MANDATORY REPLACEMENT PARTS FOR SHOCK ABSORBERS

THE HIMARS' TM 9-2300-310-14&P DOESN'T LIST ANY MANDATORY REPLACEMENT PARTS CRITERIA FOR THE FRONT SHOCK ABSORBERS.

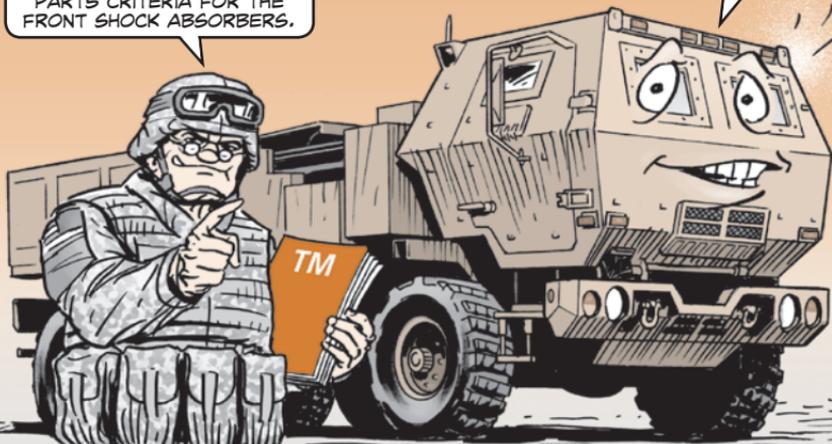
AS A RESULT, THERE'S A CHANCE THE FRONT FRAME RAILS COULD BE BENT OVER THE RUBBER BUMPER ON THE FRONT LEAF SPRING.

SO THE FOLLOWING PARTS MUST NOW BE REPLACED EVERY TIME THE FRONT SHOCK ABSORBERS ARE REMOVED OR REPLACED...

IN ADDITION, THE SHOCK ABSORBERS, NSN 2510-01-372-4839, MUST NOW BE REPLACED AS PART OF THE BIENNIAL SERVICES.

Item	Name	NSN
1	Self-locking screw	5310-01-369-6706
3	M16 cap screw	5305-01-369-8253
4	Machine bolt	5306-01-369-8192
6	Flat washer	5310-01-369-8923
7	Self-locking nut	5310-01-369-3339

Item	Name	NSN
1	Cap screw	5305-01-433-8469
2	Flat washer	5310-01-158-9053
3	Self-locking nut	5310-01-369-6706
5	Cap screw	5305-01-369-2264

THIS INFORMATION WILL BE ADDED TO TM 9-2300-310-14&P.
